HMMWV....

# SMART START SYSTEM CONTROL BOX BUZZ

S3 control box, NSN 6110-01-542-7901,  
replaces EESS control box

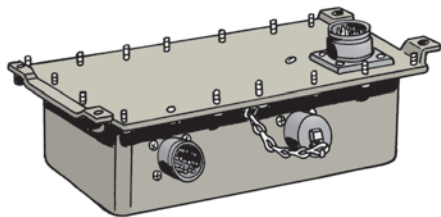
Some people didn't get the word that the S3 control box, NSN 6110-01-542-7901, is replacing the engine electrical start system (EESS) control box, NSN 6110-01-491-2158. The S3 was put into HMMWV production starting with serial number 255269.

When you order the S3, you'll get the S3 box and the temperature sensor. The biggest difference between the EESS and the S3 is that the S3 control box has three connector receptacles, while the EESS control box has only two. The plan is to use the third connector receptacle on the S3 control box in the future for troubleshooting and data logging.
